**Seismic Walkdown Checklist (SWC)**Equipment ID No. 2X41-C010A Equip. Class<sup>1</sup> 9Equipment Description DG 2C ROOM FAN 2ALocation: Bldg. DIESEL Floor El. 150 Room, Area ROOF

**Seismic Walkdown Checklist (SWC)**

**Seismic Walkdown Checklist (SWC)**

4: Cover Plate with Sheared Screw Head (2X41-C010A)

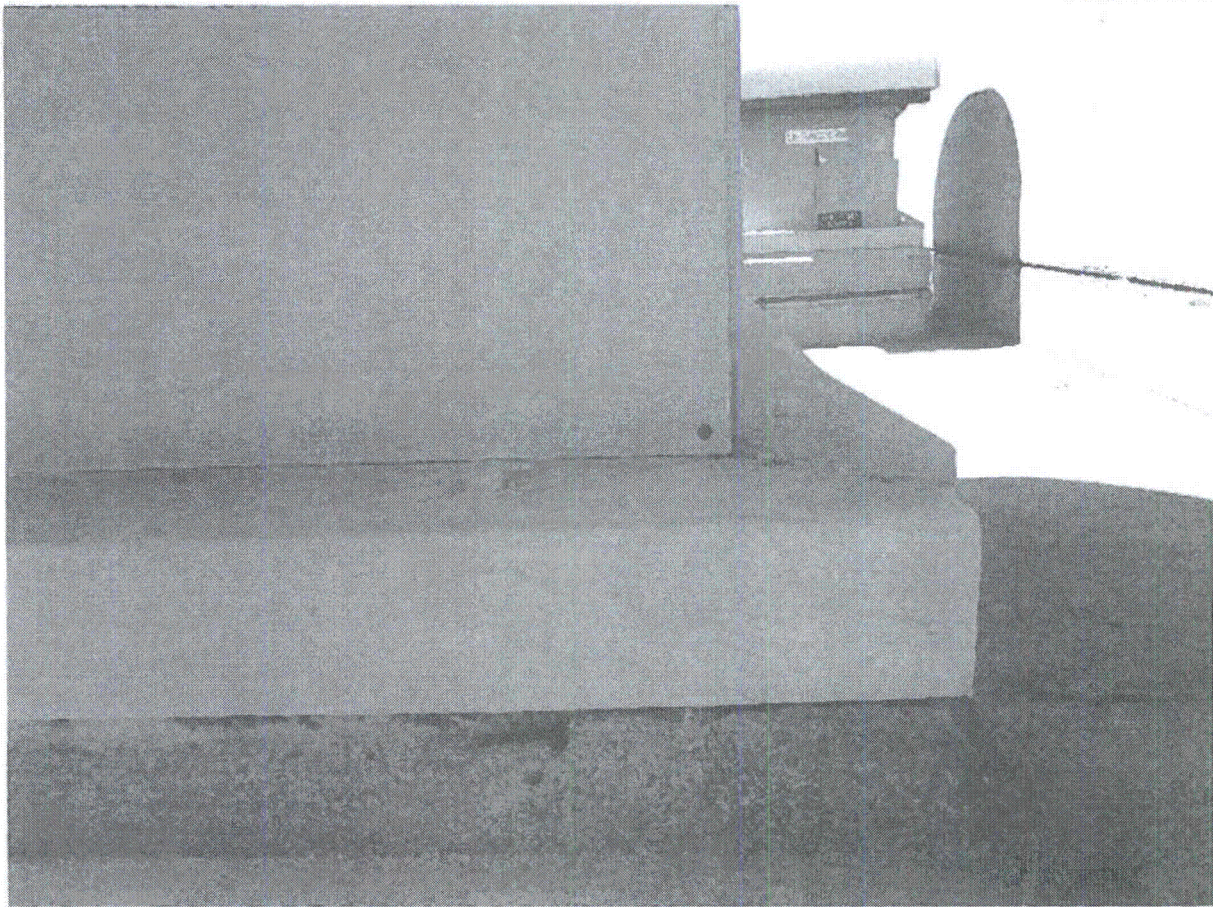
*A screw on the east side cover plate that the head has been sheared off (see photograph 4). There are three other screws supporting the plate, which is judged to be adequate to secure it in place. The damaged screw is not a seismic concern. CR 523328 has been written to replace the screw.*

Figure 3 – Broken Grating Section (2T41-B003B)

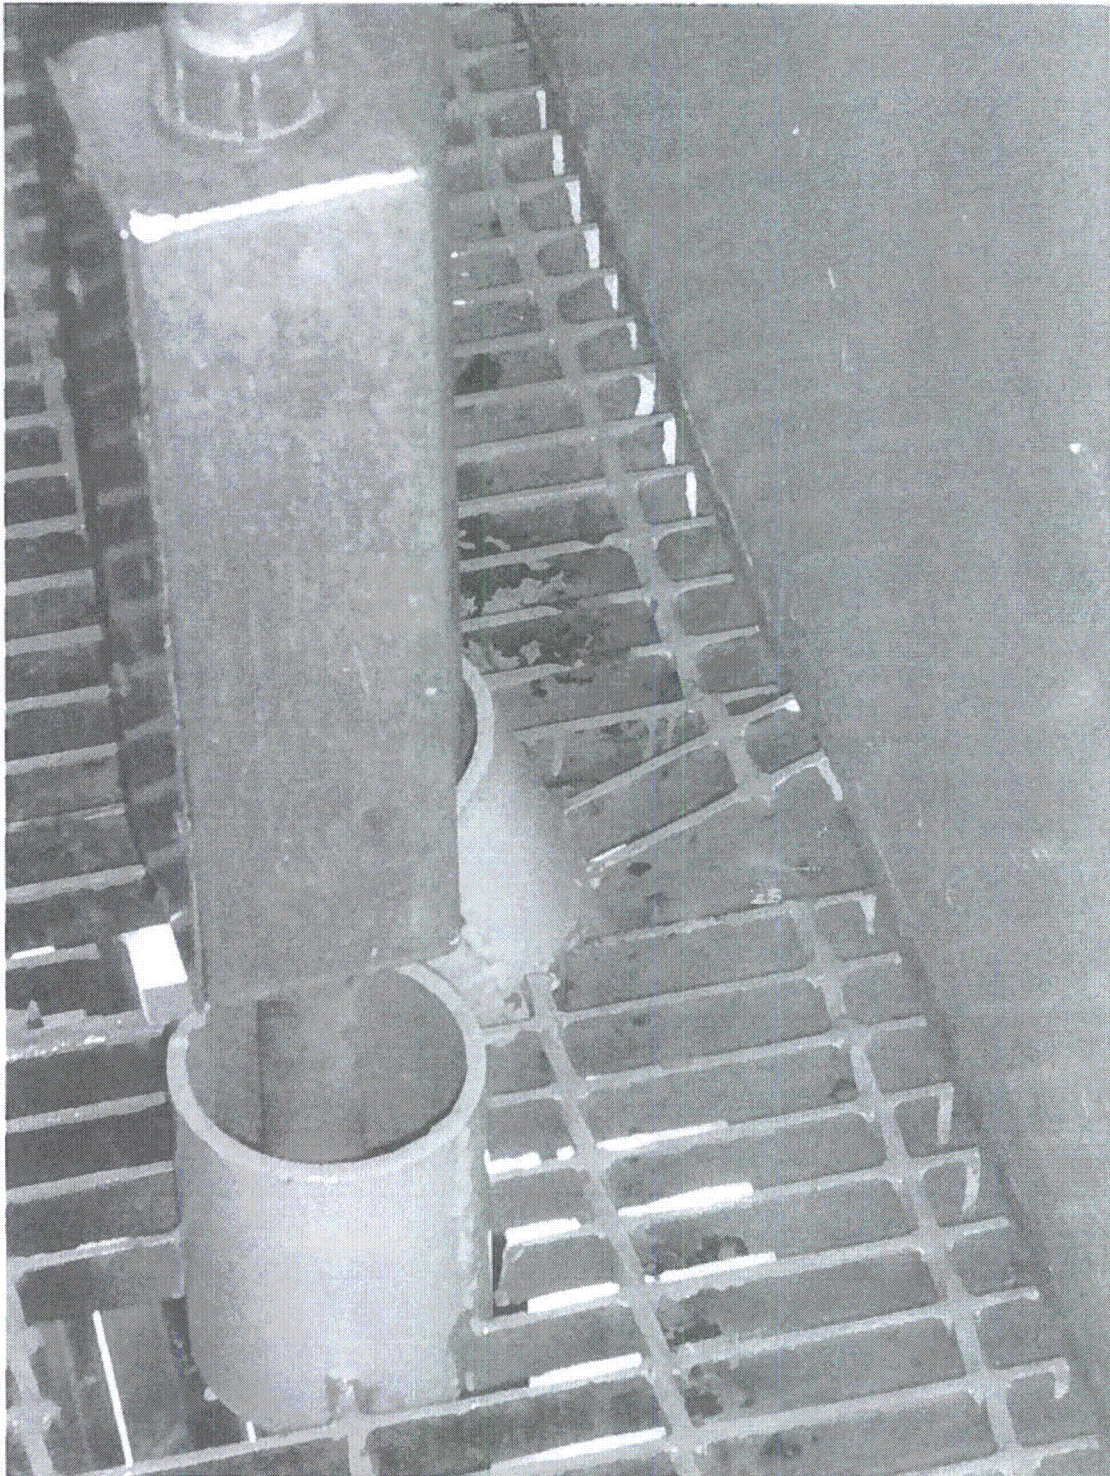
*There is a small section of grating broken near the corner of the 2T41-B003B RHR/CS Pump Room Cooler. The section of grating is extremely small and is welded to the kick plate around the pipe going through the grating at that location. The grating is not in immediate danger of separating and becoming an impact hazard and does not affect the larger grating panel's ability to support load. Therefore, it has been judged to be seismically adequate.*

Figure 3 Typical View of Anchor Configuration of Component

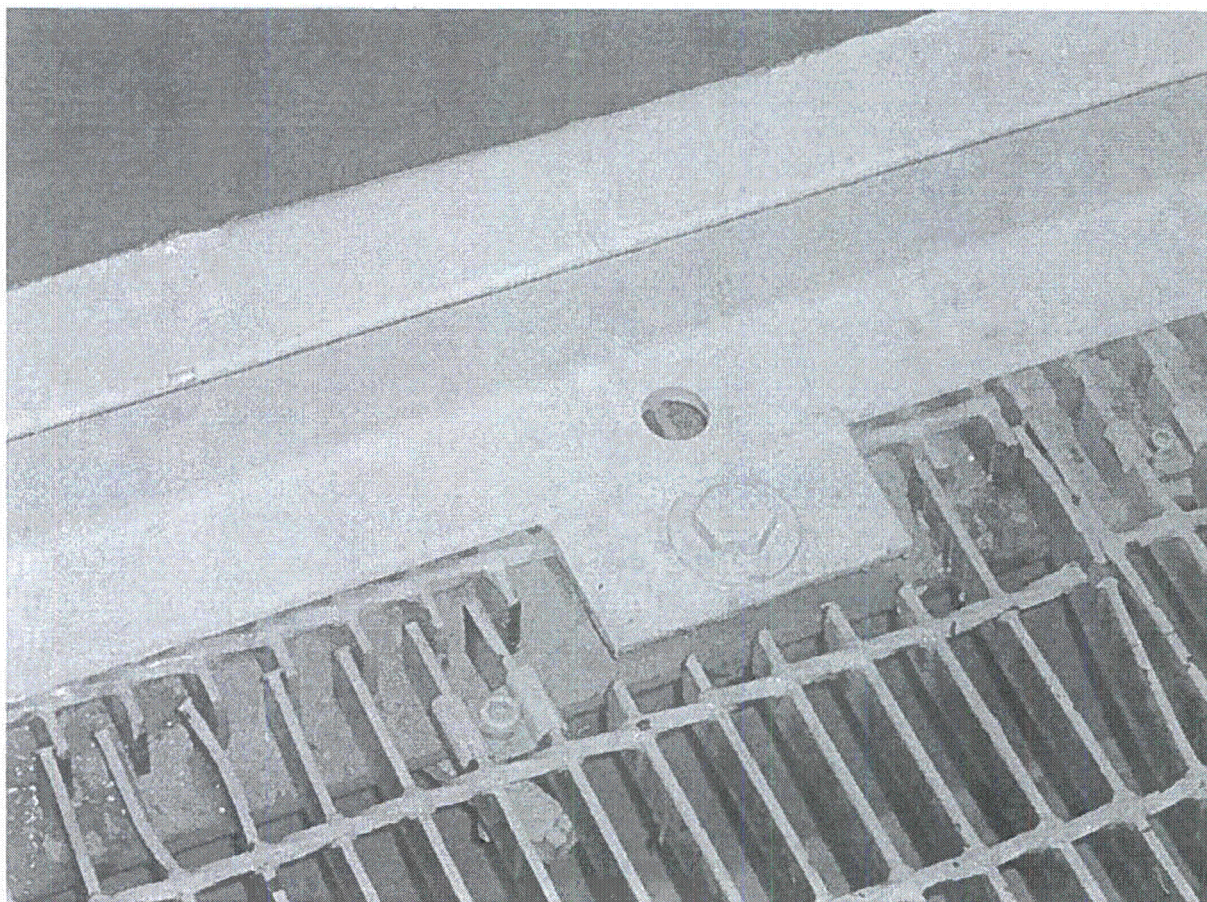
2. Is the anchorage free of bent, broken, missing or loose hardware? Y  N  U  N/A   
*Holes with missing anchors but replaced with tabs and new anchors. SWE's have determined that this configuration is acceptable and consistent with anchorage shown in SQUG package based on referenced SEWS package and Calculation*

Figure 4 View of Casing Missing Cap Screws

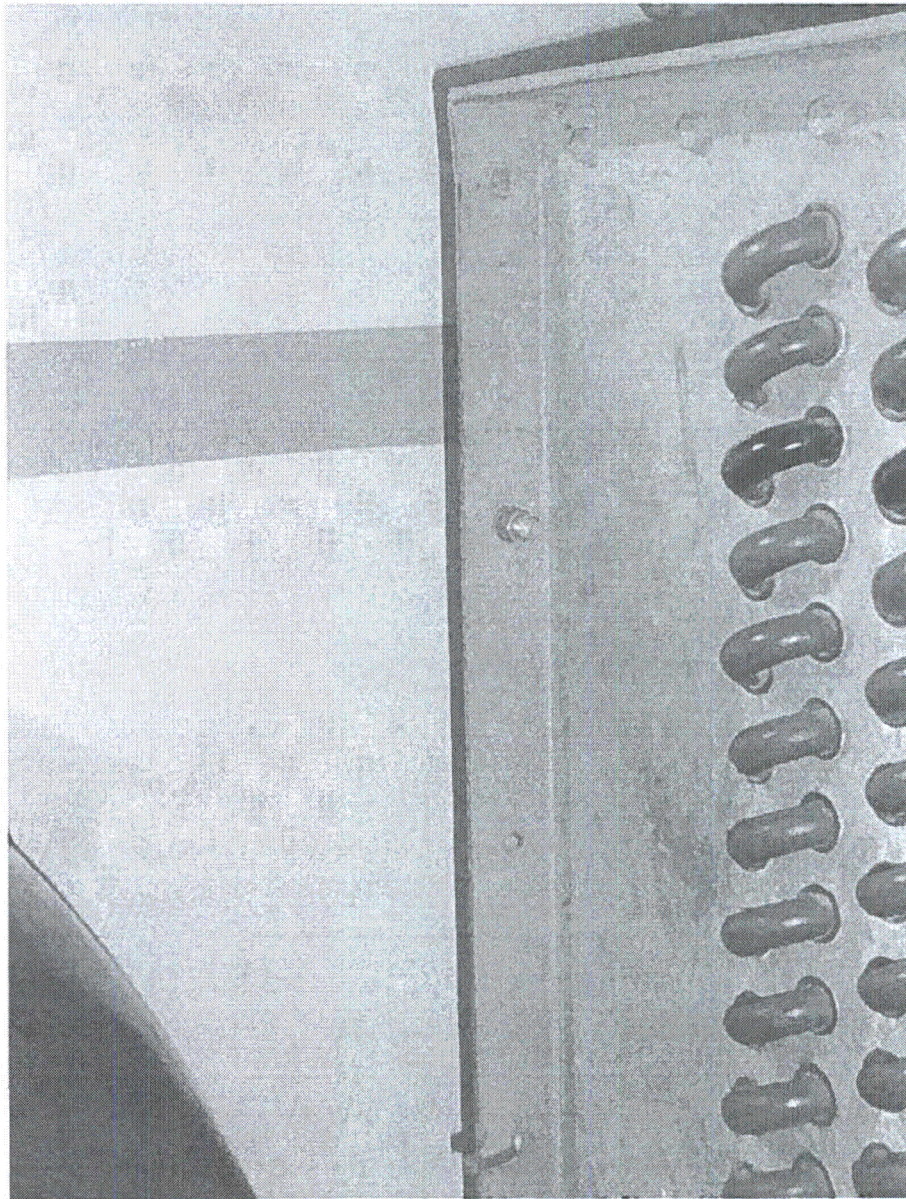
*There are missing housing cap screws these cap screws have no matching hole in the mating flange to place a screw. Therefore, the missing cap screws do not pose a seismic issue for the component.*

Cut cable shown coming from the panel.

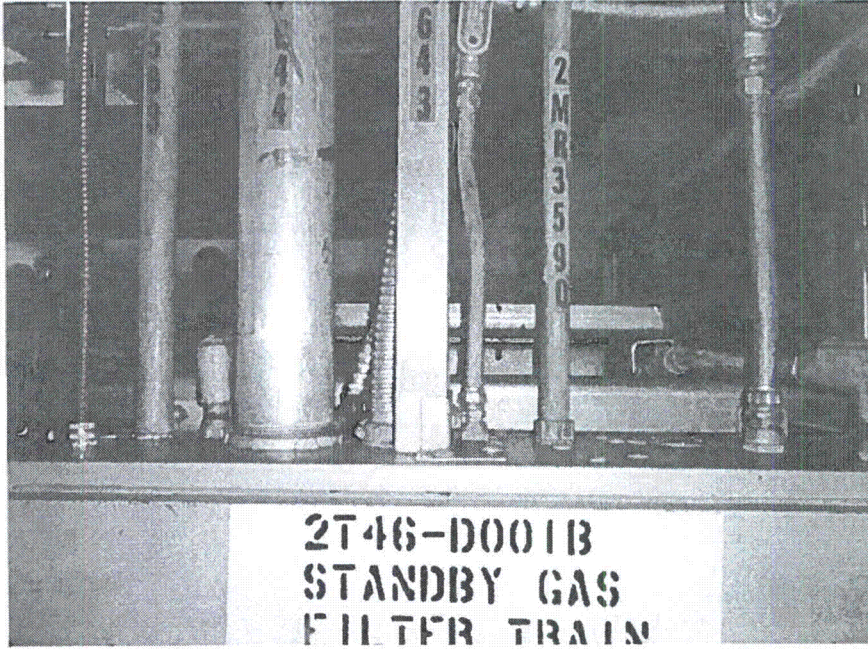
*Cut cable was spotted above the panel for the train. A CR has been initiated to identify the cable and cap it (CR516629).*

Figure 3 – Small Gap between Panels (2P33-B001B)

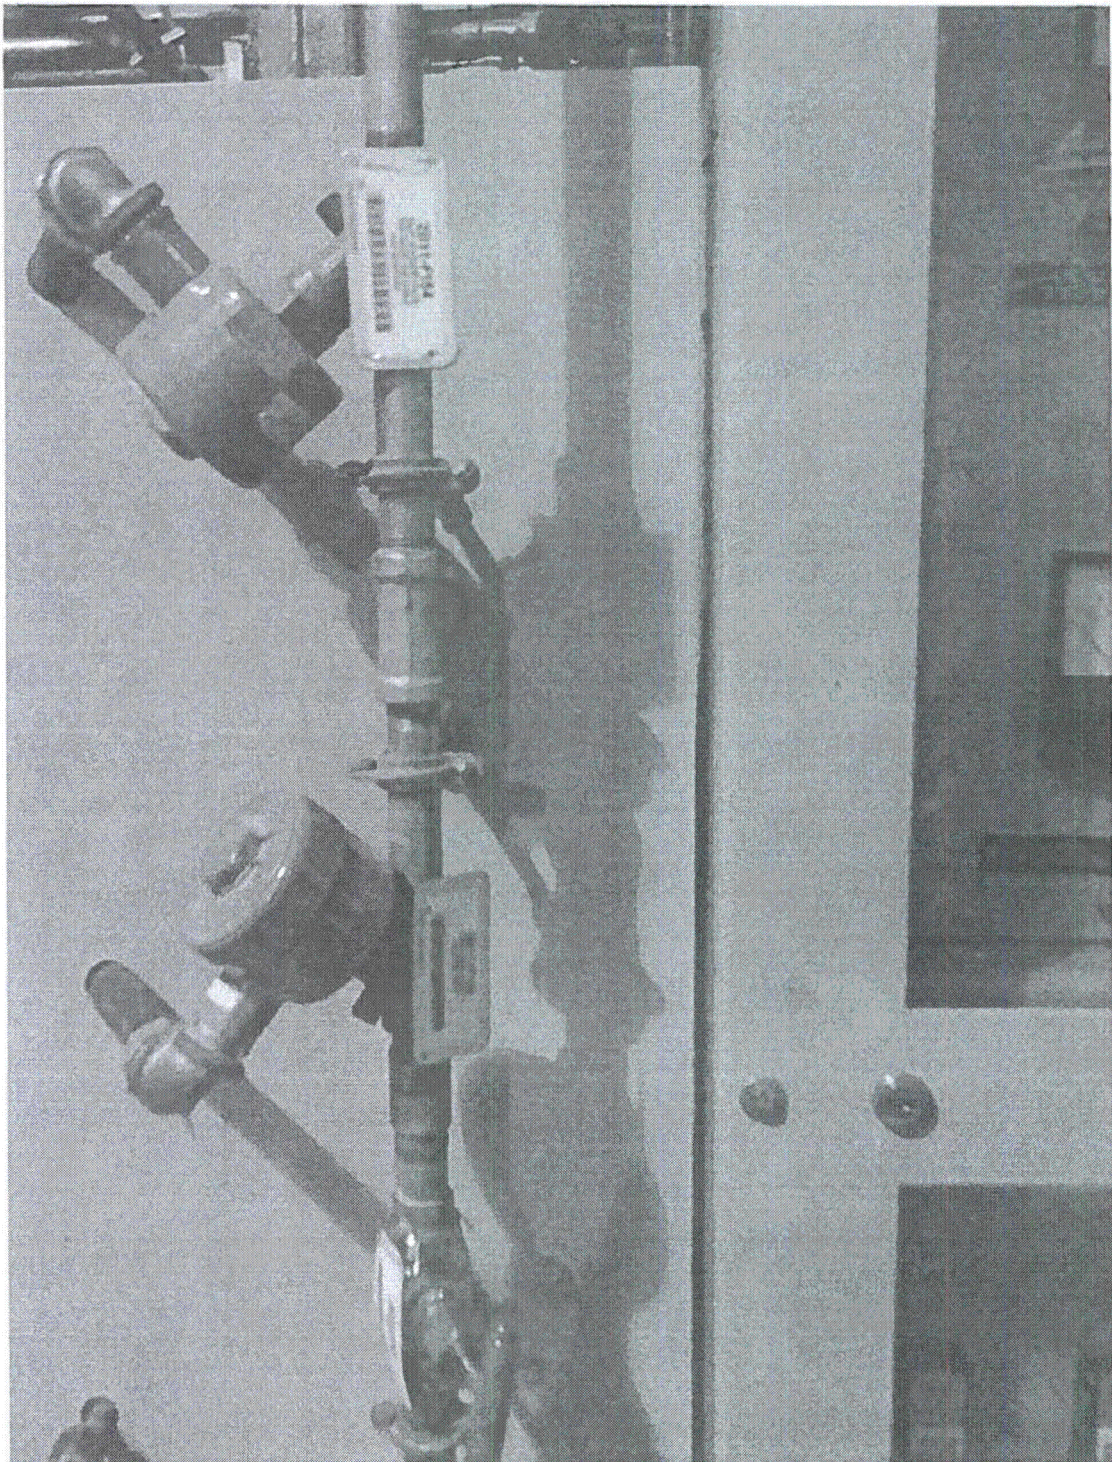
- 7. Are soft targets free from impact by nearby equipment or structures? Y  N  U  N/A   
*Panel 2D11-P010 sits next to H2/02 Analyzer Sample Chiller-2P33-B001B. There is between a 1/16" and a 1/8" gap between the two components, and the components are not tied together. During a seismic event, it is likely that the two will impact one another. However, per conversations with a recent former systems engineer for this system, there are no essential relays or similar sensitive equipment inside either cabinet, so the impact does not have the potential to create a condition that is adverse to plant safety. The impact between the cabinets will not have enough force to damage the rugged cabinets, so it is judged that there is no potentially adverse seismic condition.*
